Re: Site Plan Review
Berry Surveying & Engineering
The Village at Barrington Square
Dove Development Group, LLC
Tax Map 235, Lots 2 1-1 & 3

Based on comments from the Review by CMA Engineers (CMA #1205 Task 40), we respectfully submit the following comments and revisions based on a telephone call between CMA and BS&E the morning of October 27, 2021. Our comments are in **bold**.

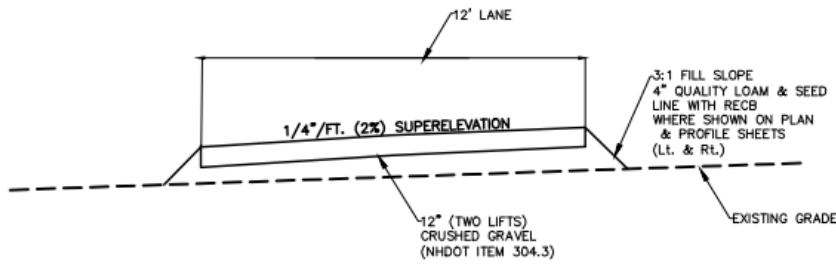
8. *It is standard practice to install catch basins with deep sumps within the roadway to collect stormwater and provide preliminary treatment. CMA Engineers does not understand what purview NHB or NH F&G would have over these catch basins and why they would recommend deviating from this standard practice. Please clarify.*

As noted by telephone due to the proximity of the project to protected turtle species, NH F&G will not permit along with AoT the deeps sumps on this project. This is a standard BMP in areas such as this. Enclosed is a snip of the wild life study that has been submitted to NH F&G with the recommendations.

- o There are no sumps in any of the catch basins
- o All outlet structures will have filled bases to allow escape
- o All structures placed in grassed areas will have Bee Hive grates to remove the potential for animals to enter the rims in the grassed areas.
- o Rip rap is reduced the extent practical
- o All matting / erosion control blankets are natural fiber and not plastic products.
- o All sedimentation barriers are either natural fiber silt sock or mulch berms
- o Pond seeding specification are pollinator friendly.
- o Curbing is designed as sloped granite, not vertical.

TYPICAL ROADWAY SECTION DRIVEWAY RECONSTRUCTION
70+00-72+25
 NOT TO SCALE

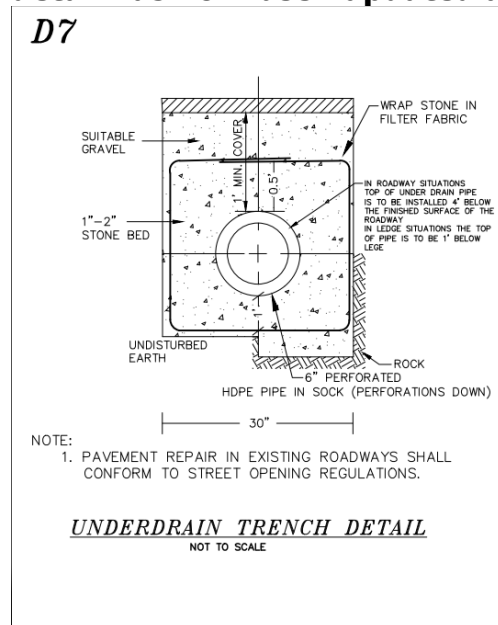
15. *Typical Roadway Section Driveway Reconstruction was not revised to replace Bank Run Gravel (NHDOT Item 304.2) with Crushed Gravel (NHDOT Item 304.3)*
This has now been corrected on Sheet 97 of 109.

One example of the modification. Overlook Drive Station 23+75 to 25+00. Changes made throughout the project as needed.

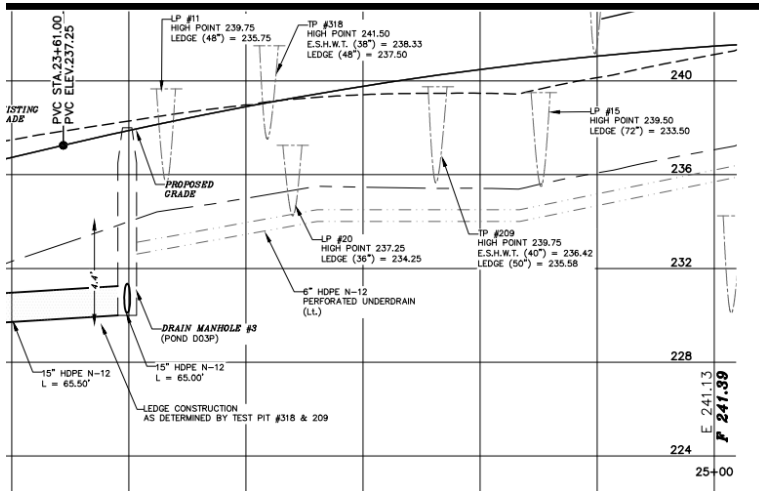
17 (e). *Standard and accepted engineering and construction practice is to install underdrain 4 ft to 6 ft deep to properly drain groundwater and frost conditions. At the depths proposed by BS&E, there's no assurance that the underdrain would function. CMA Engineers recognizes that the proposed roadway is constructed near ledge, and we recommend underdrain be installed so the top of pipe is at least 1 ft below ledge.*
The project Plans have been modified throughout to now have the underdrain 4' below finished grade and keyed into ledge (where applicable) so the invert is 1.5' below ledge surface. The corresponding construction detail has now been updated as well.

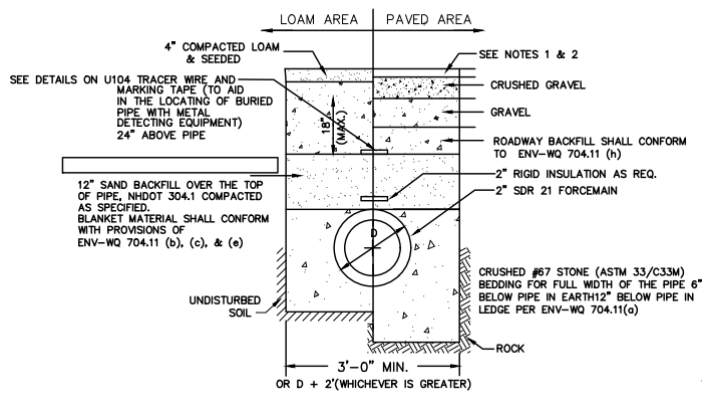
(f). *CMA Engineers agrees with the straighter pipe runs. Sheet 102, Typical Sewer Pipe Trench, the detail does not show tracer wire installed over the sewer force main. We recommend tracer wire be added to the detail.*

Sheet U104 (Sheet 103 of 109) was added for detail and clarity, however Detail U22 on U-103 (Sheet 102 of 109) needed correlation as discussed by telephone. This detail has been updated to include a tracer wire callout and have referenced further details on U-104.

TYPICAL ROADWAY SECTION COMMUNITY WAY

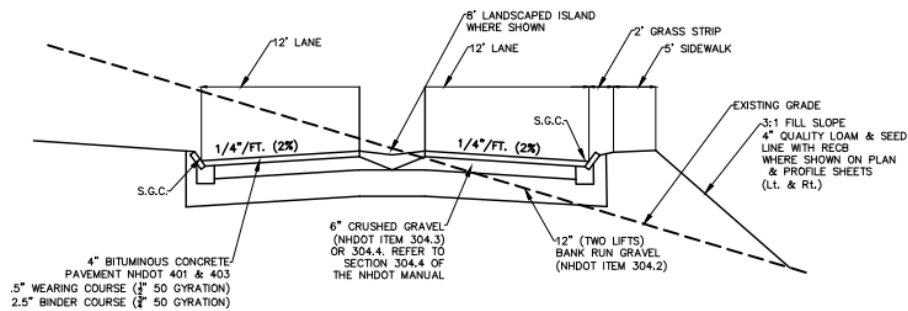
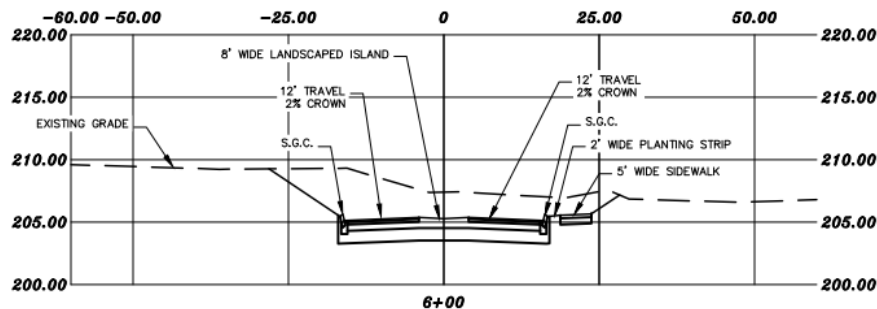
19. *Sheets 106-109, truck turning Motions have been updated across the project; however, truck turning motions remain tight allowing little to no margin for error. This is largely due to the center islands on Community Way. The consequence will be that wheels may drift off the pavement onto the islands. We recommend that BS&E confirm that the islands are designed to withstand such occasional movements/loadings.*

Sheet 108, Truck turning motions provided are for vehicles turning to/from the access road and the driveway in a southerly direction, but the house is in the northerly direction. Please provide truck turning motions for vehicles turning to/from the access road and the driveway in a northerly direction towards the house.

As discussed by telephone, we agree to connect the bank run gravel in the sections for vehicle loading and extend the crushed gravel sections beyond the limits of the pavement. Cross sections have been updated as well as the typical section. In addition the site plans now call for concrete noses to be added to the islands in the event of rollover. With respect to directional flow of the fire truck related to the private drive, as discussed by telephone it is not intended that this be the sole access to the house only a secondary use as needed for potential circular pattern.
